UNLIREC/ITB-010/2017

Procurement of two containerized test firing facility at 20ft and 40ft

Inquiries

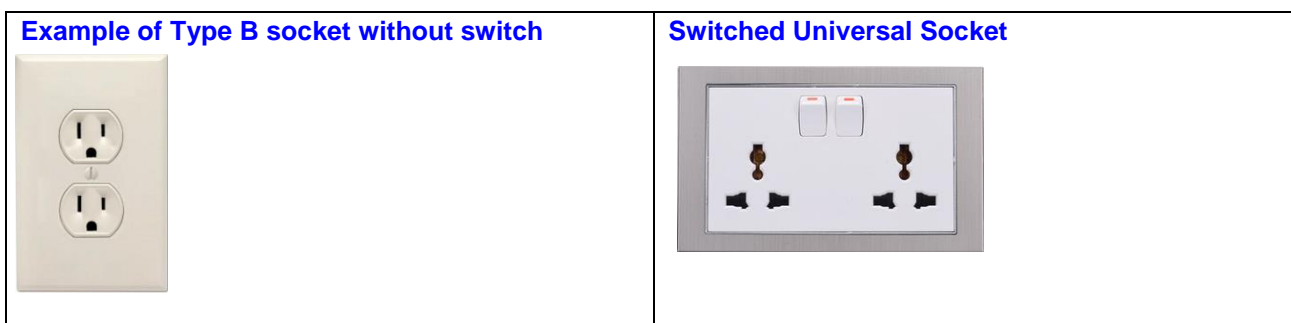
Please can UNLIREC provide pictures of the sockets required, so that the correct items can be proposed/supplied.

ANSWER: The 3 sockets can each be either:

1. **Switched**, double sockets, Type B or
2. Universal switched socket or
3. Double sockets, Type B with a separate switch box beside it.
